From: JLucas1099@aol.com
Sent: Monday, June 12, 2017 4:40 PM
To: Germinario, Lena@Waterboards
Subject: Tent. Ammending Order NPDES Permit/ Lehigh Water Treatment?SC Co Zoning Hearing
Attachments: Lehigh Water Treatment Facility - Zoning Administrator Hearing - May 4

In regards RWQCB Tentative Orders Amending Order Nos. R2 2014-0010 (NPDES Permit CA0030210) and R2-2014-0011 (Cease and Desist Order), Lehigh Southwest Cement Company and Hanson Permanente Cement, Inc. Permanente Plant, Santa Clara County, I am attaching details of Santa Clara County Zoning Officer's recent May 4 review of Lehigh Water Treatment Facility that I request be incorporated in record for RWQCB Tentative Orders Amending Order Nos. R2 2014-0010 and 0011 in continuation of my 6/8 comment.

This Santa Clara County Department of Planning and Development Architecture and Site Approval, Design Review, and Grading Approval - 2250-17A-17DR-17G (Lehigh Water Treatment Facility) of a 159.42 acre site is deemed ancillary and accessory to the Cement Plant, and includes a 9,100 square foot building, on a pad which necessitates 2,976.6 cubic yards (CY) of cut and 2,220.9 CY of fill for building footprint and associated out

Attachment E

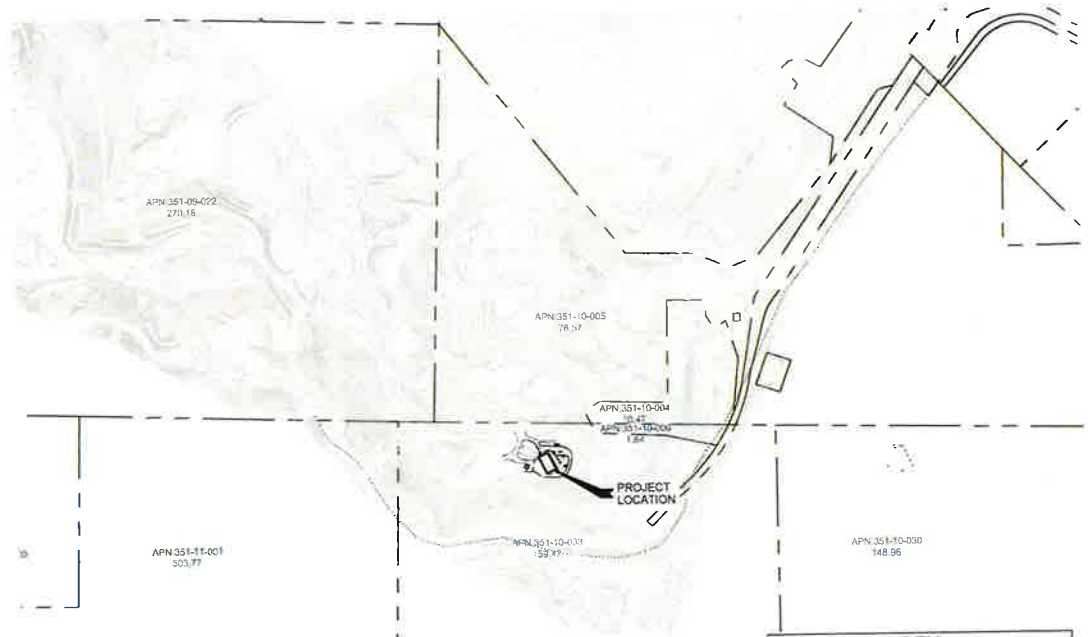
On page 8 of this transmitted staff report please note Technical Details of Facility Operation to be assured that details are in compliance with RWQCB NPDES Permit relative to water circulation from ponds to plant.

"Currently, water is collected at the Cement Plant primarily in Pond 1 and Pond 11. Pond 1 water is pumped to the Permanente Quarry Main Pit. Extraction wells surrounding the Main Pit draw water out of the ground and the water is currently sent to the Interim Treatment System at Pond 4A to be treated before being discharged into Permanente Creek. The capacity of the Interim Treatment System is only 400 gallons per minute. The proposal includes redirecting the water from the extraction wells to the proposed Facility, which will have a capacity of 1,200 gallons per minute. The proposed Facility will replace existing interim Treatment System located near the Main Pit at Pond 4A. See Attachment E for a Flow Schematic."

Is this increase in pump power critical to facility operations in consideration of its probable lethal impacts to Red-Legged Frog populations that inhabit full extent of Upper Permanente Creek watershed? What water rights are intrinsic to these extraction wells pumping of groundwater adjacent to main quarry pit? To increase pump power in extracting groundwater from wells will extend de-watering of underflow of Permanente Creek?

CIVIL
PRELIMINARY OVERALL PLAN

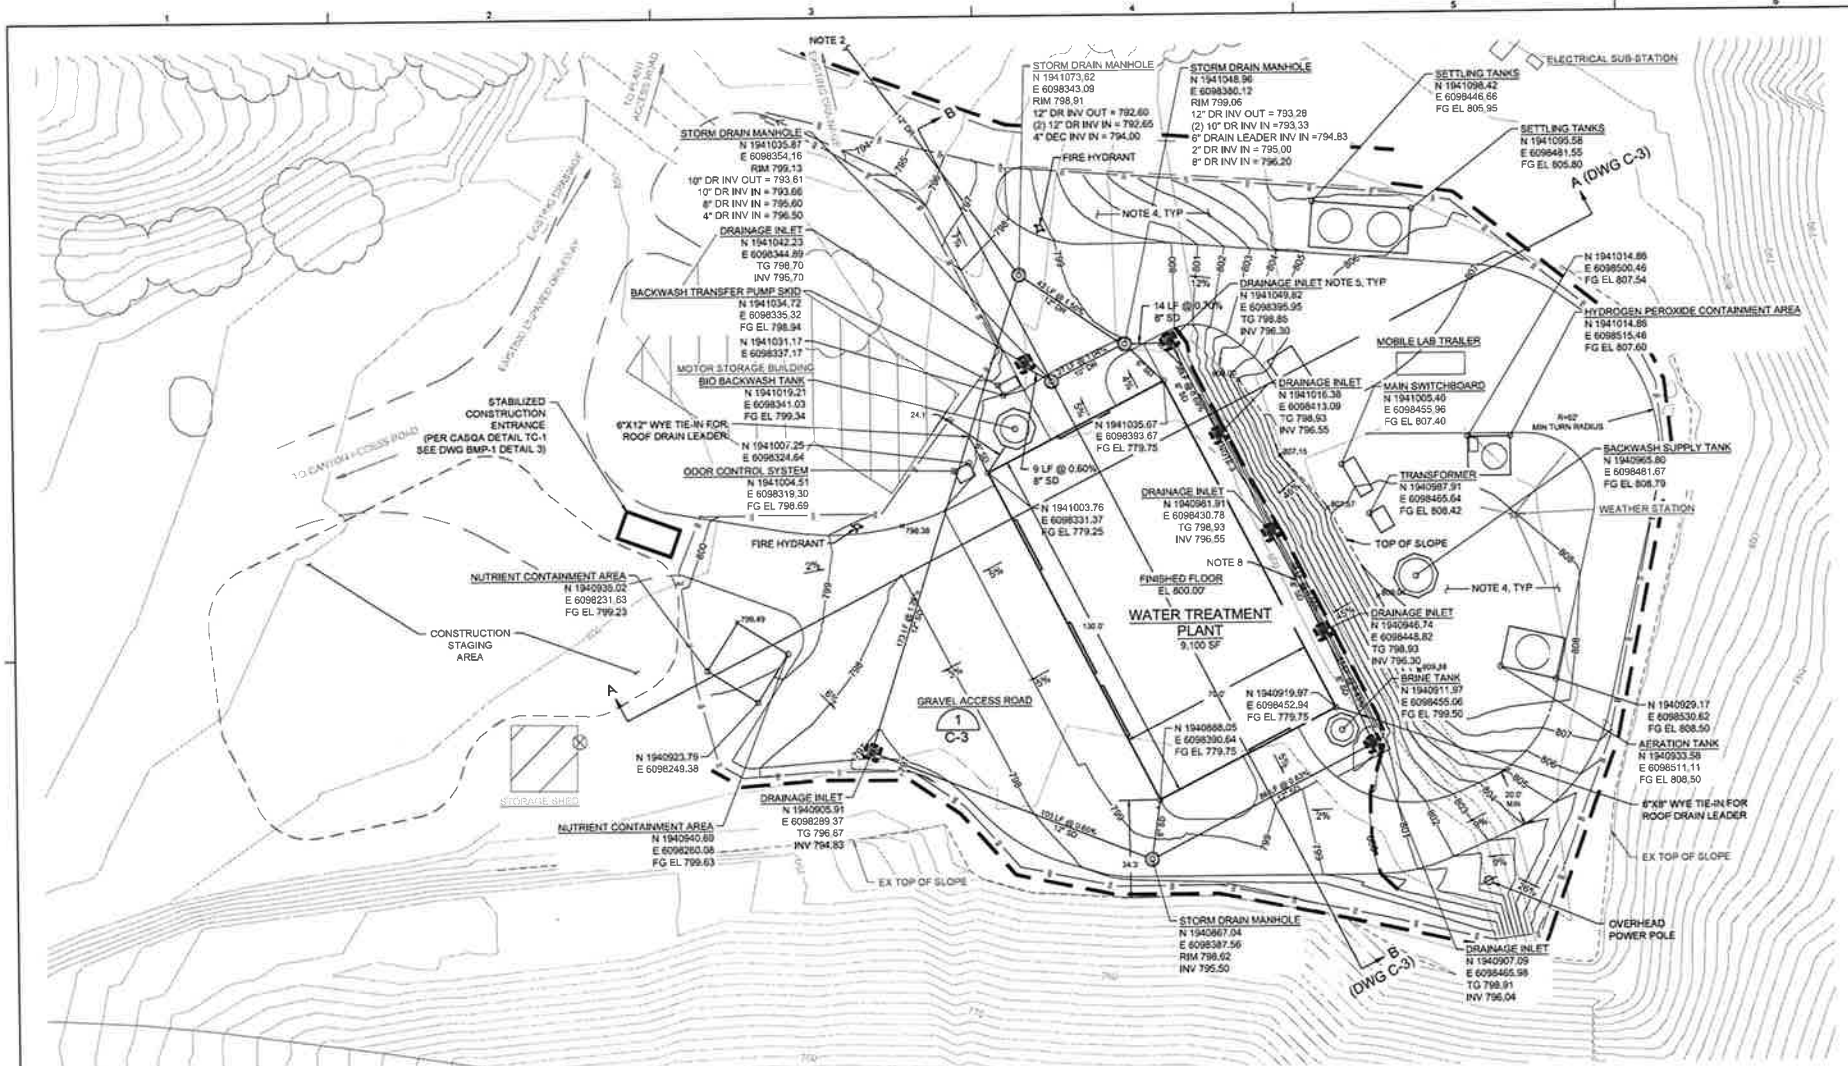
4. Where on site will project construction and activities occur (describe and show on site plan construction footprint and staging areas)? Lehigh's Response- The process water treatment plant will be constructed on an existing storage yard area, as shown on the overall site plan.

Comment – There has been no mention of any soil samples taken from the propose treatment plant site prior to any removal of any soil this needs to be part of the application and it is not. The construction will be on shaky ground and even if the soil is replaced there is a strong possibility that the ground will be subjected to earth quakes and shifting ground. There is a steep drop of 100 ft. that could cause a serious life hazard for the persons working in the treatment plant this needs to be addressed. There is more said on this topic in the Geological Report but this information needs to be added to the application in order to comply with the application. The storage yard is full of old metal and rusted out equipment and has been used as a dumping ground this needs to be addressed because it has probably been adding to the soil and water pollution from Lehigh.

FLOOR PLAN
3/16" = 1'-0"

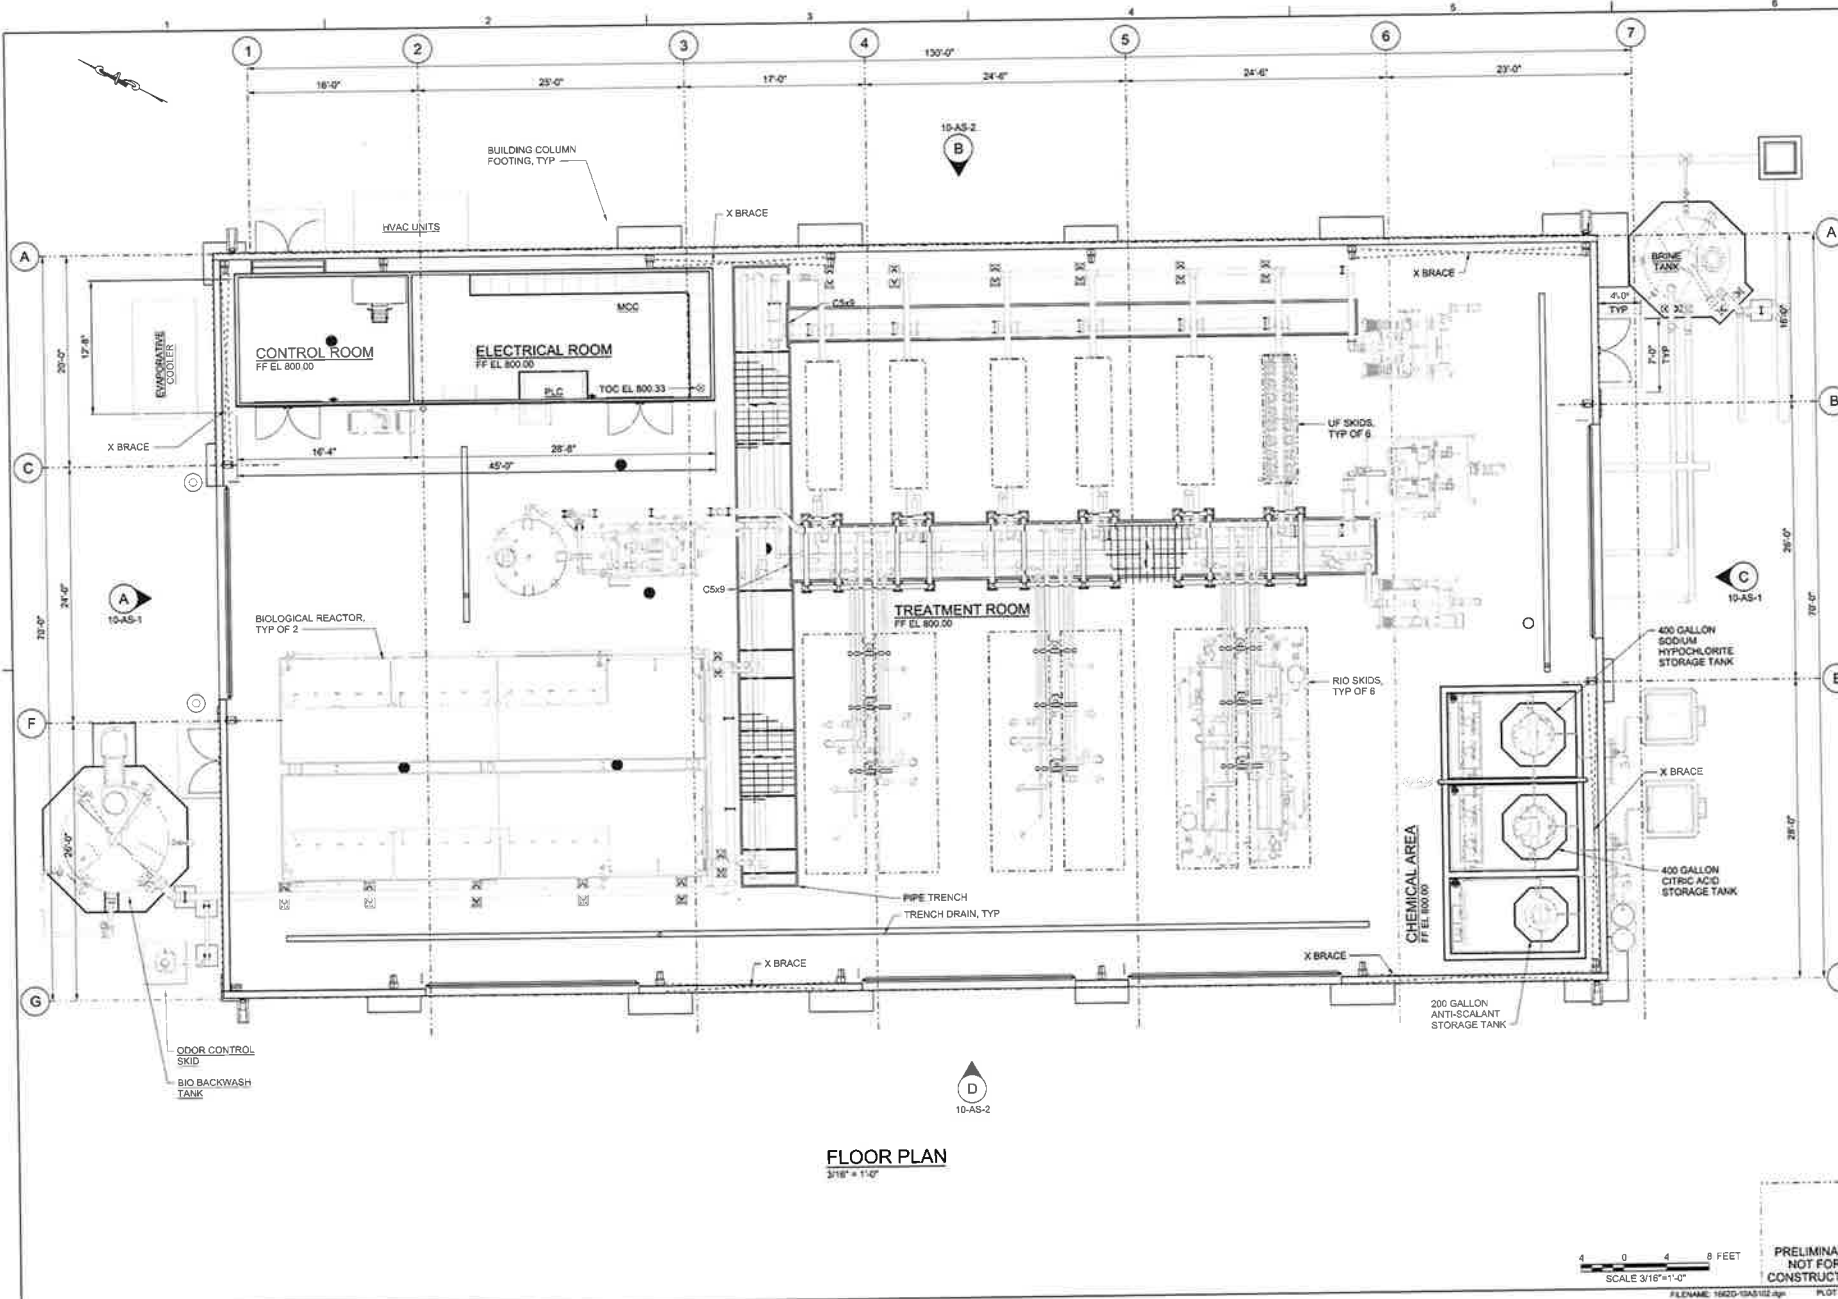
In recommended and approved plant design these tanks of chemicals are stored within building. The only outside tank shown is to store backwash' Proximity to earthquake faults demands special integrity in design.
